## MEMORANDUM

To: Zoning Board  
From: Lauren A. Wasilauski, Open Space & Stewardship Director  
Date: February 27, 2023  
Re: BA-07-22 The Malvern School Properties, LP  
Block 28010 Lots 57 & 58  
982 Georgetown-Franklin Turnpike (Somerset County Route 518)

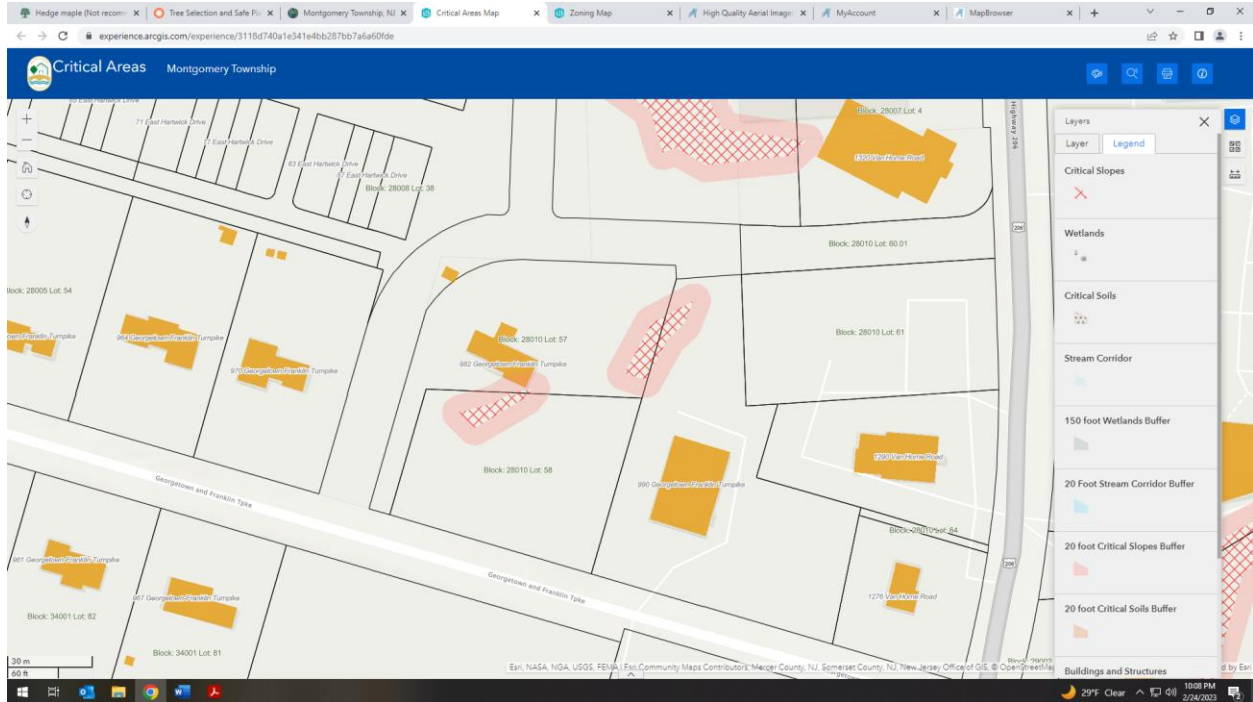
1. There are steep slopes on the property which the EIS report attributes to previous construction activities for the existing single-family dwelling (map on following page). Township Code Section 16-5.6e requires conservation easements or conservation easement deed restrictions on all critical areas. Because these steep slopes are not naturally occurring, this office does not recommend a conservation easement or deed restriction on these areas.
